Memorandum

TO: Ivan Gall, Director
FROM: Ben Scandella, Darrick Boschmann; Groundwater Section
DATE: September 30, 2025
SUBJECT: Technical Evaluation of Petition to Amend Division 512

Figure 2: Map showing comparison of OWRD Proposal and Petition Proposal Critical Groundwater Area and Subarea Boundaries.

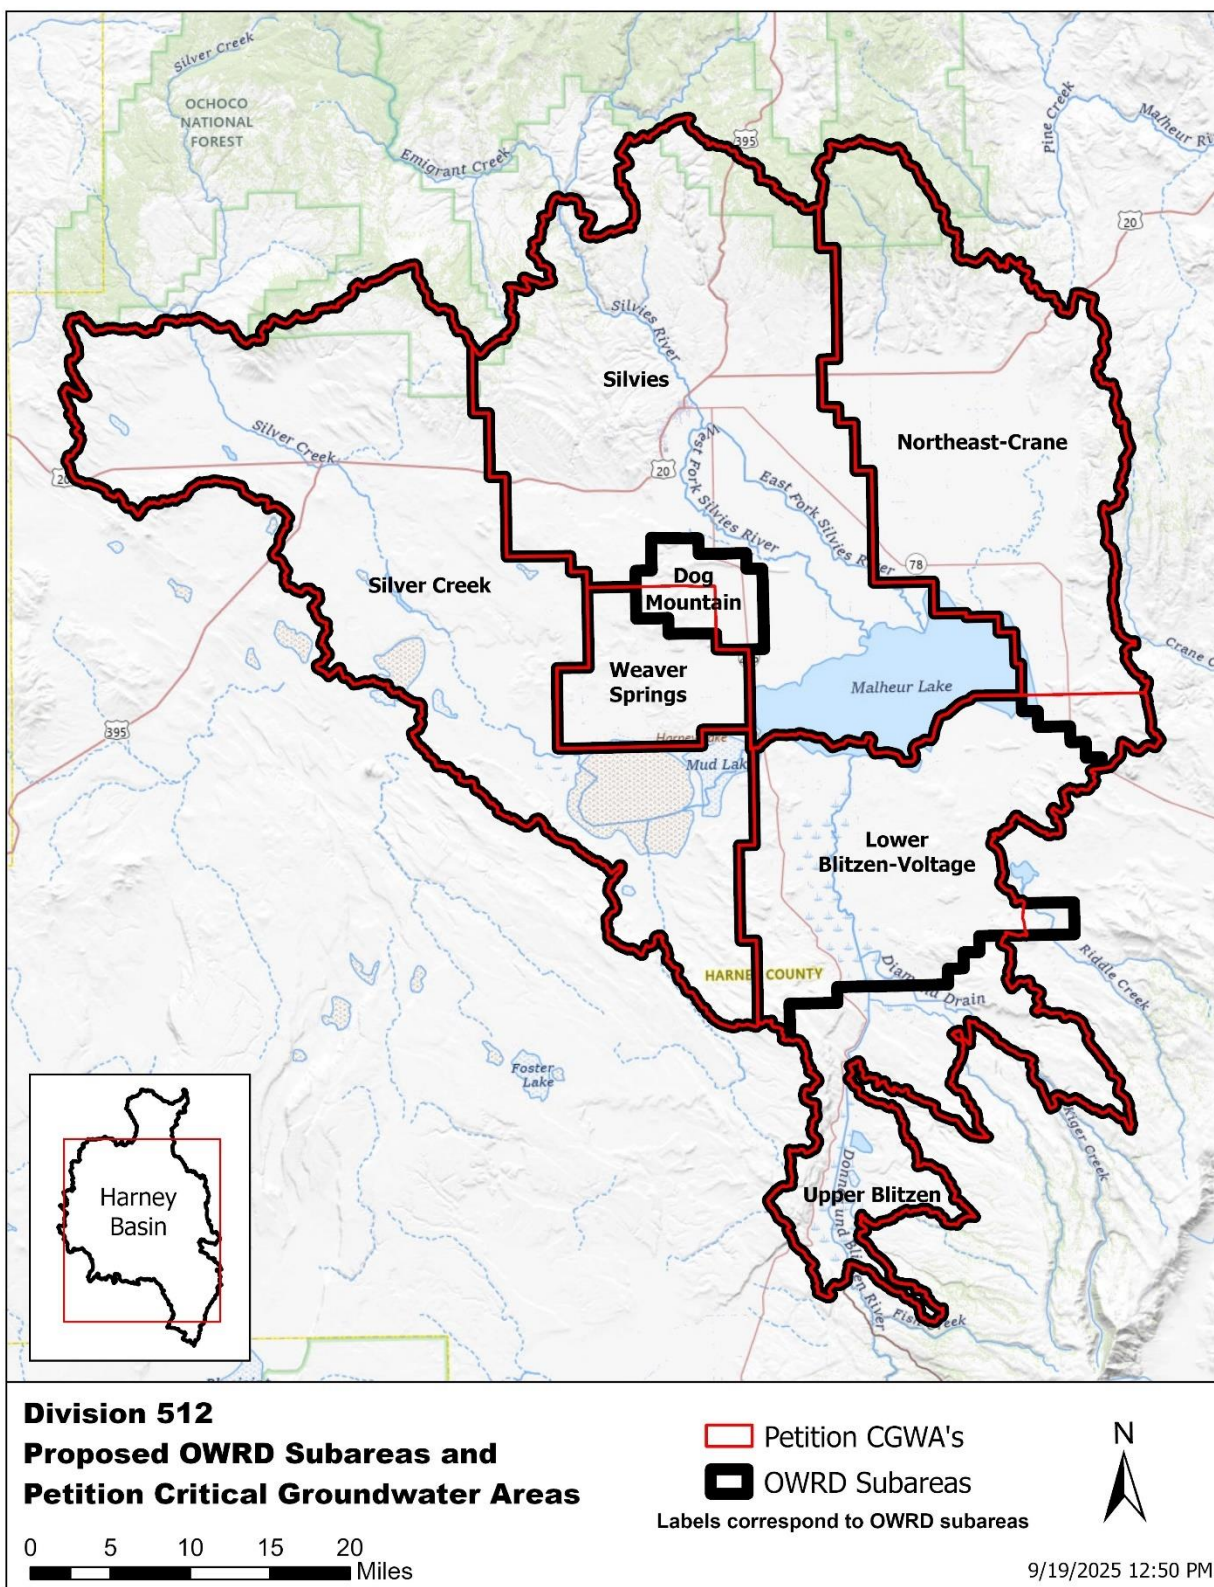
The Petition Proposal designates 5 separate CGWAs covering the Greater Harney Valley Groundwater Area of Concern as shown in Figure 2. There are four notable differences between the boundaries of the OWRD Proposal subareas and the Petition Proposal CGWAs:

- Portions of the OWRD Proposal Dog Mountain subarea are combined into the Petition Proposal Weaver Springs and Silvies CGWAs.
- The OWRD Proposal Lower Blitzen-Voltage and Upper Blitzen subareas are combined into the Blitzen-Voltage CGWA.
- The boundary between the Lower Blitzen-Voltage subarea and the Northeast-Crane subarea is shifted northward.
- The six PLSS-section projection of the GHVGAC on the southeast margin is removed.

Figure 4: Time-series of median water level change since 2018 in the OWRD Proposal Dog Mountain Subarea under the OWRD Proposal, Petition Proposal, and Full Pumpage scenario. The results of the petition proposal are aggregated over the OWRD Proposal subarea for comparison.

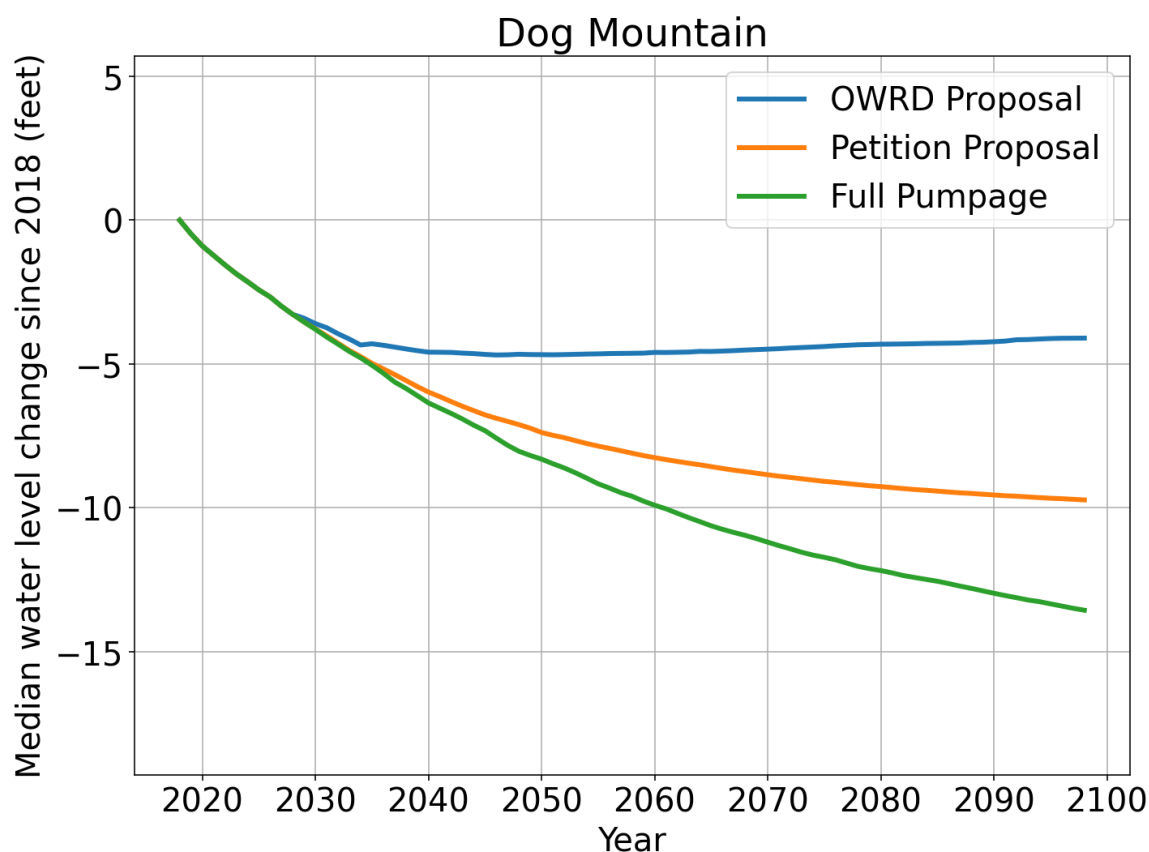
Under the Petition Proposal median groundwater level changes in the Dog Mountain subarea (Figure 4) continue to decline through the entire model period. At the end of the model period, the median groundwater level changes remain in a state of decline, and the median groundwater level change since 2018 is a decline of 9.7 feet.

Under the OWRD Proposal median groundwater level changes in the Dog Mountain subarea continue to decline until 2046, after which they stabilize and begin a slow recovery through the end of the model period. At the end of the model period, the median groundwater level change since 2018 is a decline of 4.1 feet.

Figure 5: Time-series of median water level change since 2018 in the OWRD Proposal Lower Blitzen-Voltage Subarea under the OWRD Proposal, Petition Proposal, and Full Pumpage scenario. The results of the petition proposal are aggregated over the OWRD Proposal subarea for comparison.

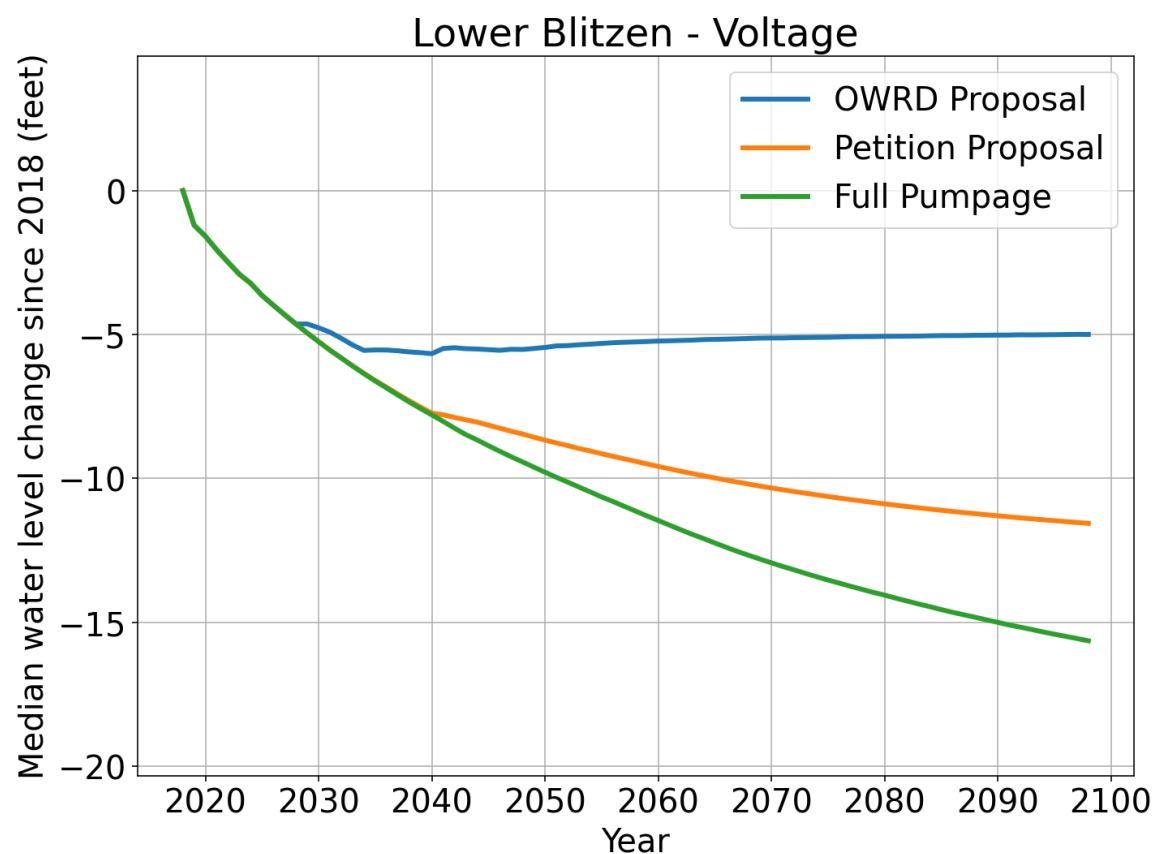
Under the Petition Proposal median groundwater level changes in the Lower Blitzen-Voltage subarea (Figure 5) continue to decline through the entire model period. At the end of the model period, the median groundwater level changes remain in a state of decline, and the median groundwater level change since 2018 is a decline of 11.6 feet.

Under the OWRD Proposal median groundwater level changes in the Lower Blitzen-Voltage subarea continue to decline until 2040, after which they stabilize and begin a slow recovery through the end of the model period. At the end of the model period, the median groundwater level change since 2018 is a decline of 5.0 feet.

Figure 6: Time-series of median water level change since 2018 in the OWRD Proposal Northeast-Crane Subarea under the OWRD Proposal, Petition Proposal, and Full Pumpage scenario. The results of the petition proposal are aggregated over the OWRD Proposal subarea for comparison.

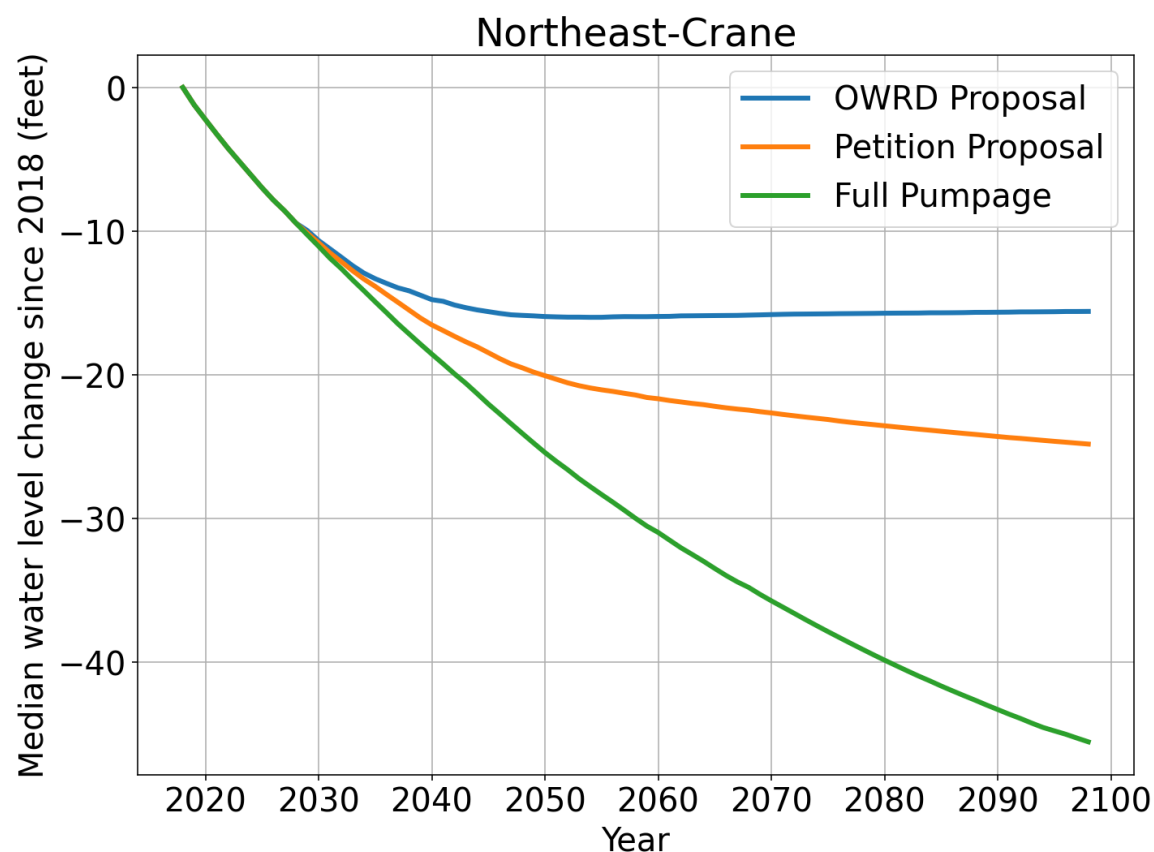
Under the Petition Proposal median groundwater level changes in the Northeast-Crane subarea (Figure 6) continue to decline through the entire model period. At the end of the model period median groundwater level changes remain in a state of decline, and the median groundwater level change since 2018 is a decline of 24.8 feet.

Under the OWRD Proposal median groundwater level changes in the Northeast-Crane subarea continue to decline until 2054, after which they stabilize and begin a slow recovery through the end of the model period. At the end of the model period, the median groundwater level change since 2018 is a decline of 15.6 feet.

Figure 7: Time-series of median water level change since 2018 in the OWRD Proposal Silver Creek Subarea under the OWRD Proposal, Petition Proposal, and Full Pumpage scenario. The results of the petition proposal are aggregated over the OWRD Proposal subarea for comparison.

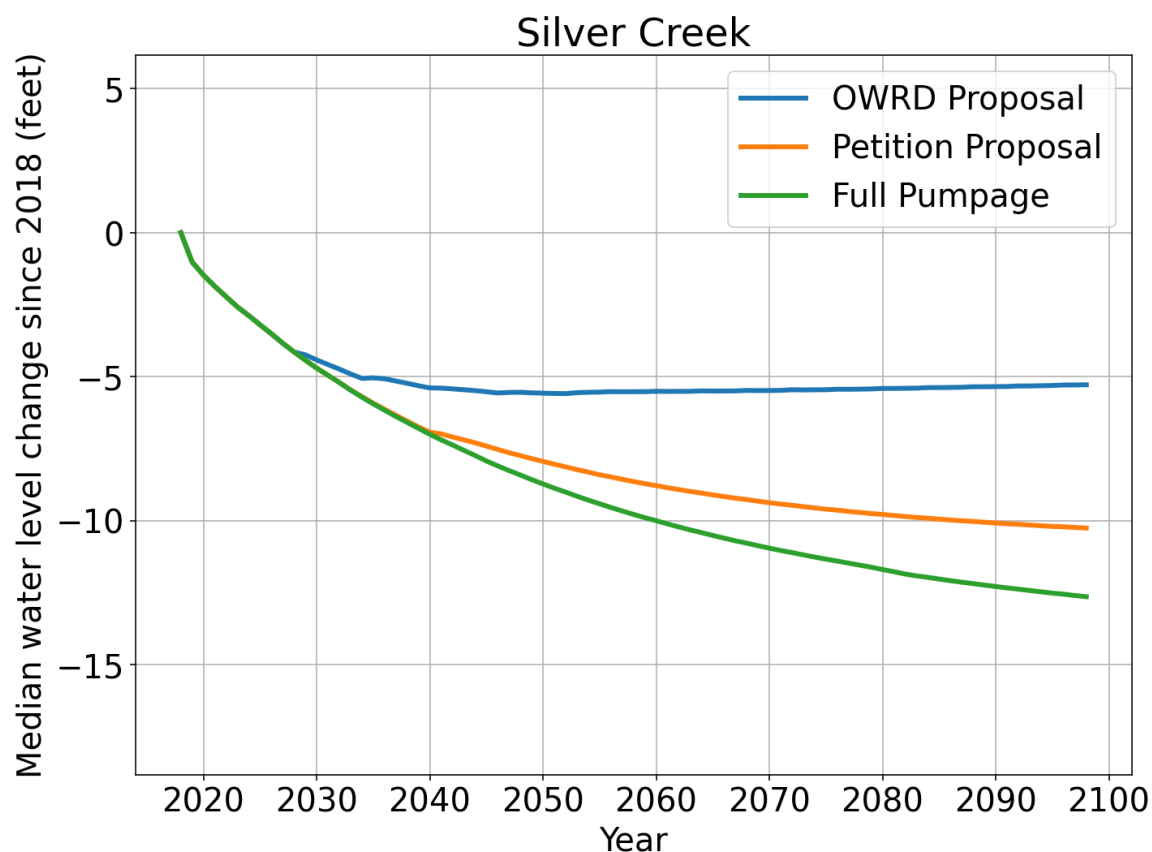
Under the Petition Proposal median groundwater level changes in the Silver Creek subarea (Figure 7) continue to decline through the entire model period. At the end of the model period, they remain in a state of decline, and the median groundwater level change since 2018 is a decline of 10.3 feet.

Under the OWRD Proposal median groundwater level changes in the Silver Creek subarea continue to decline until 2052, after which they stabilize and begin a slow recovery through the end of the model period. At the end of the model period, the median groundwater level change since 2018 is a decline of 5.3 feet.

Figure 8: Time-series of median water level change since 2018 in the OWRD Proposal Silvies Subarea under the OWRD Proposal, Petition Proposal, and Full Pumpage scenario. The results of the petition proposal are aggregated over the OWRD Proposal subarea for comparison.

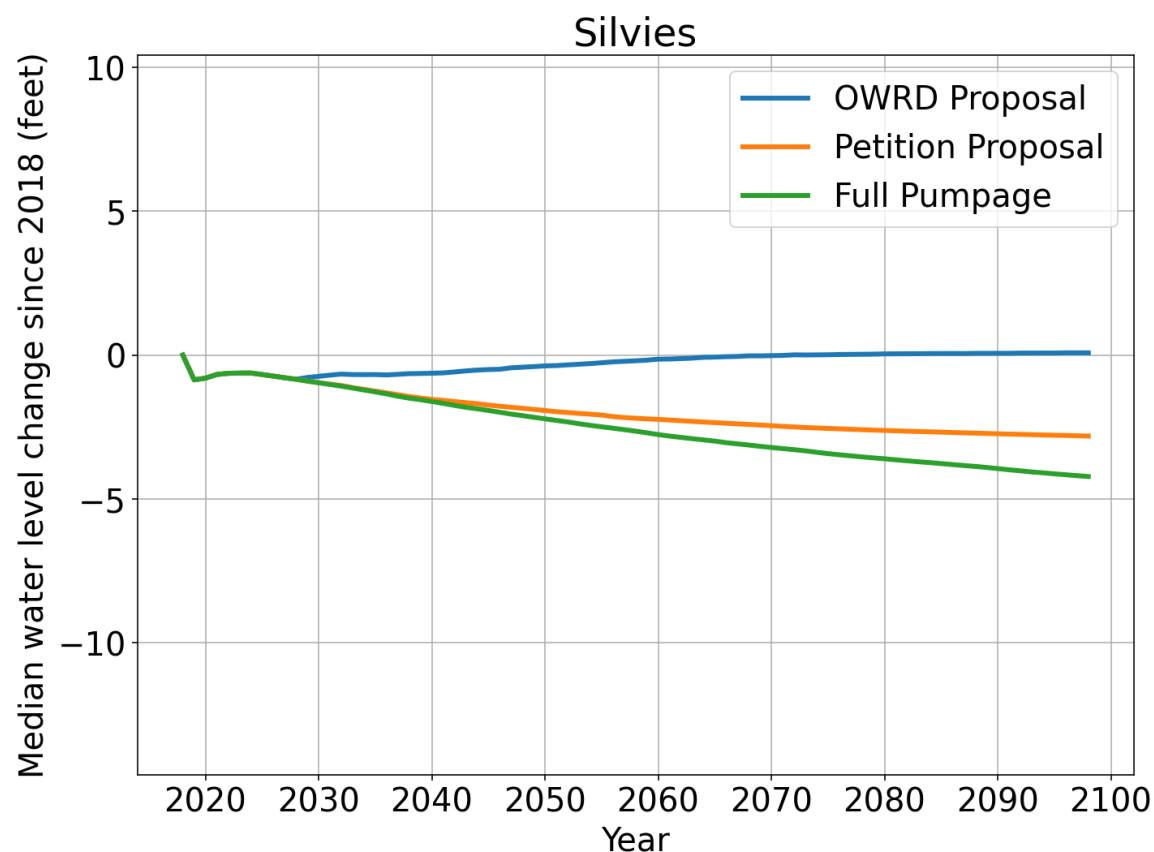
Under the Petition Proposal median groundwater level changes in the Silvies subarea (Figure 8) continue to decline through the entire model period. At the end of the model period, they remain in a state of decline, and the median groundwater level change since 2018 is a decline of 2.8 feet.

Under the OWRD Proposal median groundwater level changes in the Silvies subarea continue to decline until 2028, after which they stabilize and begin a slow recovery through the end of the model period. At the end of the model period, the median groundwater level change since 2018 is an increase of 0.1 feet.

Figure 10: Time-series of median water level change since 2018 in the OWRD Proposal Weaver Springs Subarea under the OWRD Proposal, Petition Proposal, and Full Pumpage scenario. The results of the petition proposal are aggregated over the OWRD Proposal subarea for comparison.

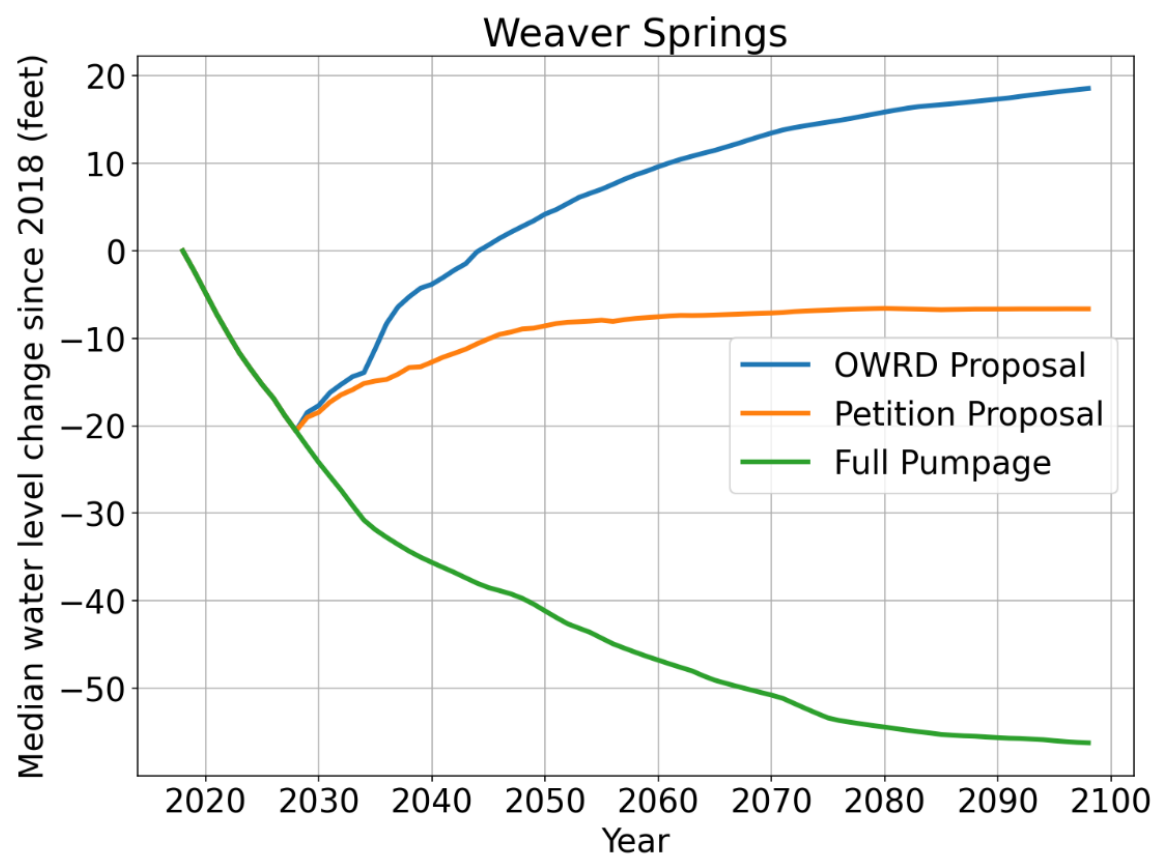
Under the Petition Proposal median groundwater level changes in the Weaver Springs subarea (Figure 10) continue to decline until 2028, after which they transition to a steady recovery until 2080 and then stabilize through the end of the model period. At the end of the model period, the median groundwater level change since 2018 is a decrease of 6.6 feet.

Under the OWRD Proposal median groundwater level changes in the Weaver Springs subarea continue to decline until 2028, after which they begin a rapid recovery through the end of the model period. At the end of the model period, the median groundwater level change since 2018 is an increase of 18.5 feet.

Figure 11: Violin plot showing the distribution of minimum interannual rates of change after 2058 for the Petition Proposal aggregated over the 5 Petition Proposal Critical Groundwater Areas. Red dashed line = median rate. Green dashed line 90th percentile rate. Black dotted line = 0.0 ft/yr.

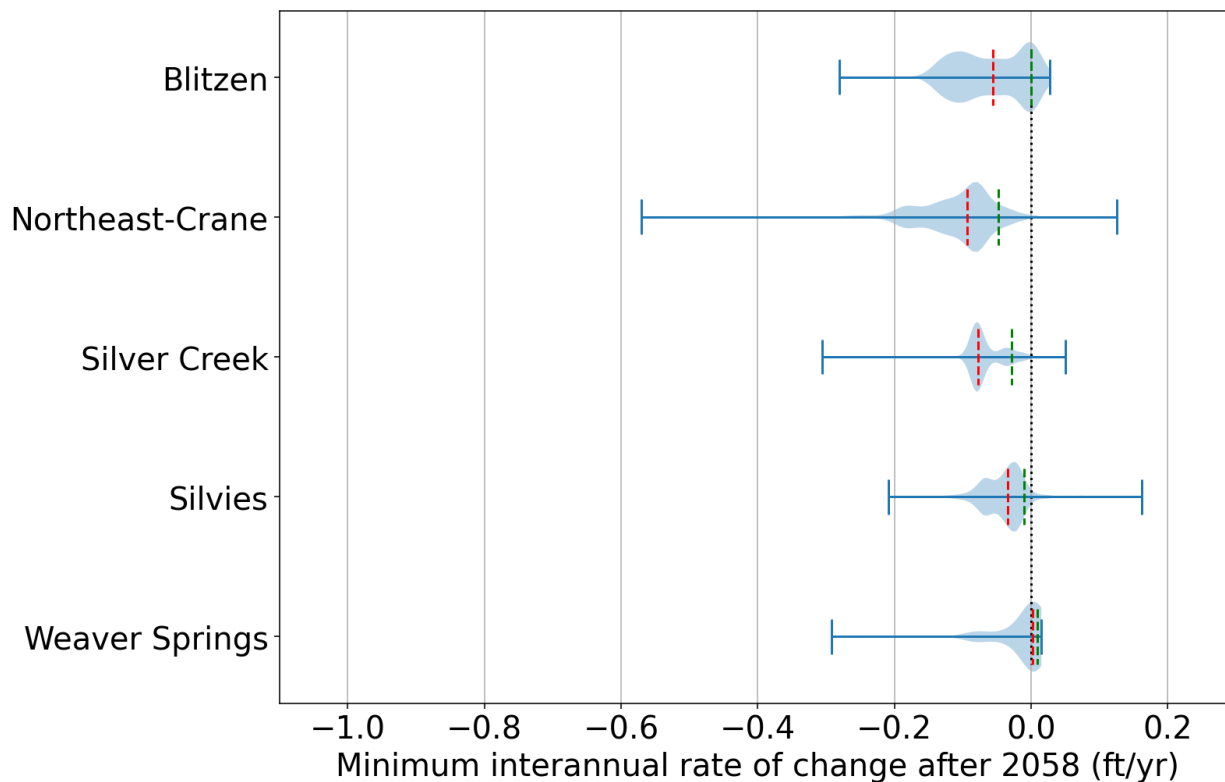
The violin plot in Figure 11 shows the distribution of minimum groundwater level rates of change after 2058 for the Petition Proposal aggregated over the 5 Petition Proposal CGWAs. With the exception of the Weaver Springs CGWA the median value (red dashed lines) is less than zero (declining) for all CGWAs, meaning that the median groundwater level change rate is not stable or rising in 2058 and does not reach stability in any model year thereafter. The 90th percentile rate (green dashed lines) is declining in Northeast-Crane, Silver Creek, and Silvies subareas, and is effectively zero in the Blitzen subarea, meaning that at least 90% of well-cells in each of these subareas are declining in year 2058 or later. Over the GHVGAC combined, 91% of well-cells continue to decline through in 2058 or later.

Figure 12: Violin plot showing the distribution of minimum interannual rates of change after 2058 for the Petition Proposal aggregated over the 7 OWRD Proposal subareas. Red dashed line = median rate. Green dashed line 90th percentile rate. Black dotted line = 0.0 ft/yr.

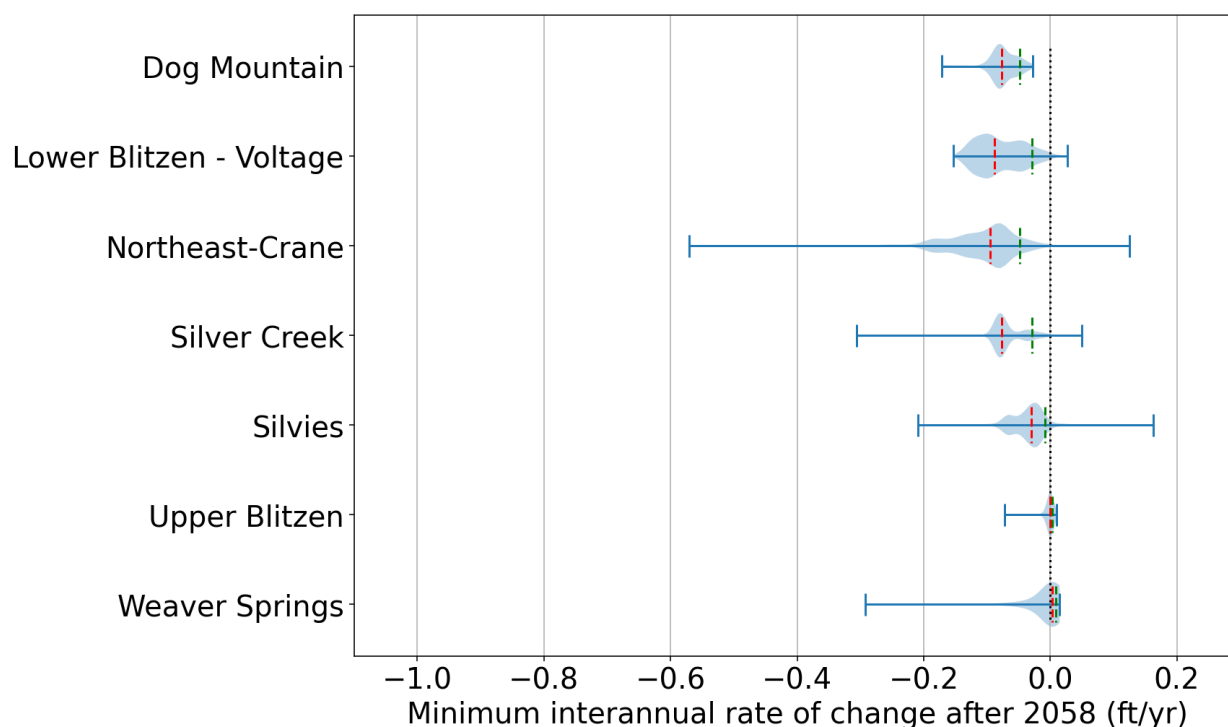
The violin plot in Figure 12 shows the distribution of minimum groundwater level rates of change after 2058 for the Petition Proposal aggregated over the 7 OWRD Proposal subareas. With the exception of the Weaver Springs and Upper Blitzen subareas both the median value (red dashed lines) and 90th percentile rate (green dashed lines) is less than zero (declining) for all subareas. This means that more than 90% of well-cells are declining in 2058 or later in each of those 5 subareas.
